COUNCIL ASSESSMENT REPORT

Panel Reference	PPSNTH-80
DA Number	DA2021/056
LGA	Nambucca Valley Council
Proposed Development	Seniors Housing (271 Self-contained dwellings, 75 bed care facility, and recreation facilities)
Street Address	24 Coronation Road, Congarinni North Lots:155 and 188 in DP: 755537 and Part Lot: 1 DP: 1000618 and Part Lot: 2 DP: 1265232
Applicant/Owner	Tony Owen Architects
Date of DA lodgement	23 February 2021
Total number of Submissions Number of Unique Objections	Total of 3 public submissions – all by way of objection. Issues raised in submissions: <ul style="list-style-type: none"> the site is inappropriate for the proposed development; bushfire hazard; flood hazard; proximity to river; environmental impact; safety of future residents who may wish to walk to town; increased traffic; impact on roads and bridges by heavy vehicles associated with the development.
Recommendation	Refusal
Regional Development Criteria (Schedule 7 of the SEPP (State and Regional Development) 2011	Capital Investment Value >\$30 Million

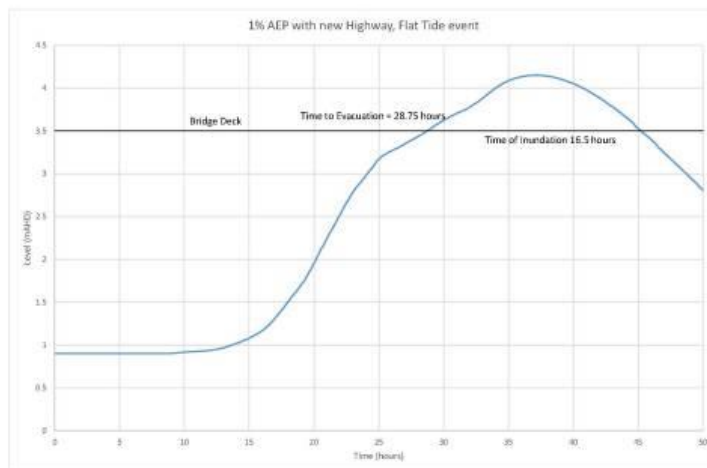
The graph below shows the development would be isolated from town for approximately 16.5hrs during a 1% AEP post highway event. During an event of this size there would be approximately 28hrs before the access becomes inundated.

During a 1 in 50 year event the site would be isolated for approximately 6hrs.
